Product Advisory

Issue Date: February 19, 2025

Component Update for Supply Continuity

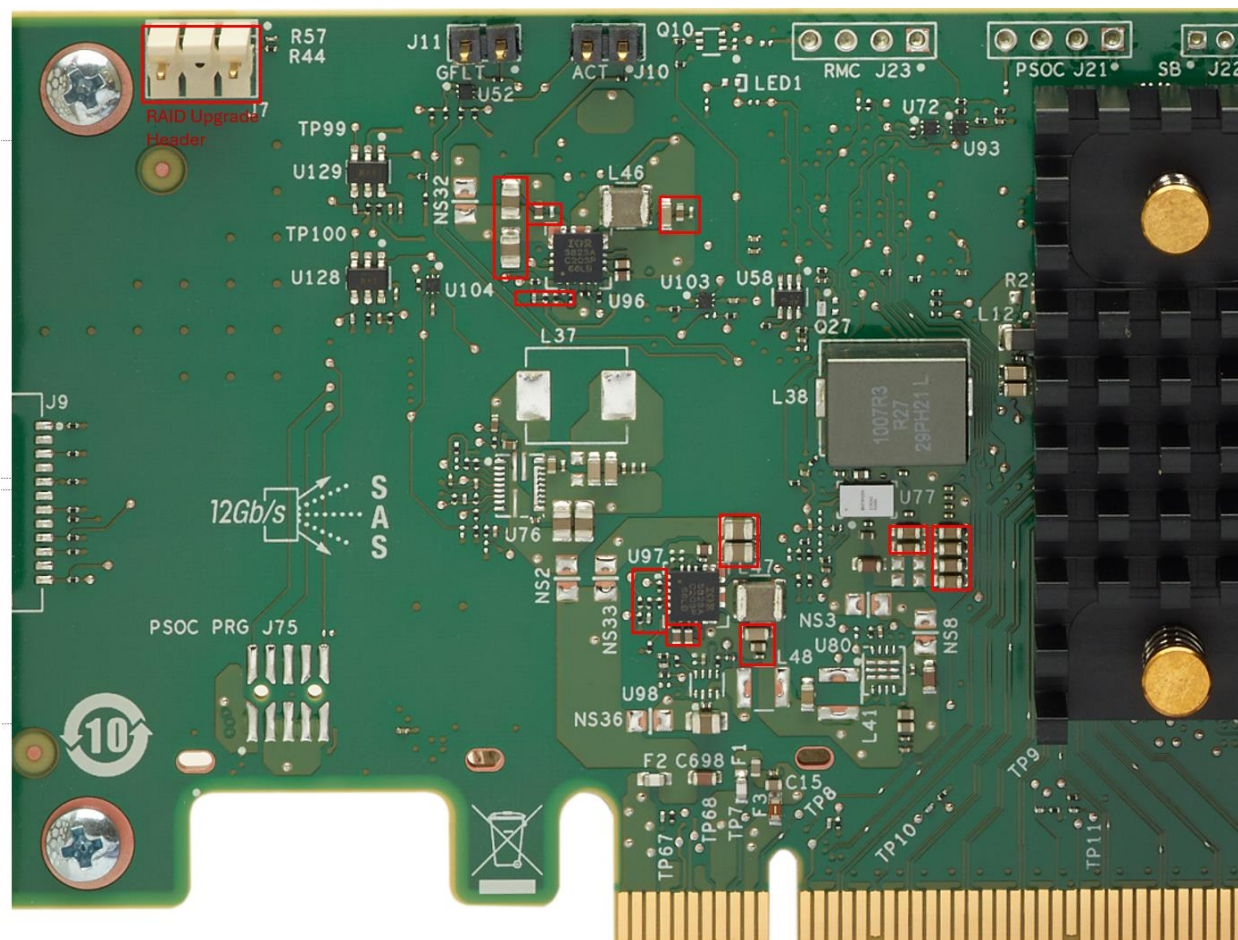
Broadcom is updating the 9500 and 9540PCBs (Model 50134) to remove unused components from the board. These boards support multiple regulator options, and depending on the regulator that is populated, the surrounding circuitry requirements may be different. Currently, components for unpopulated regulators may be populated. These components are not connected to anything. See picture below for an example of components being removed (red outlines). Further, as part of this change, the RAID upgrade header will be removed from the 9540 adapters. There is no need for the upgrade header with Aero iMR.

This change is simply to remove unused components. However, the populated components may differ from shown depending on the regulator
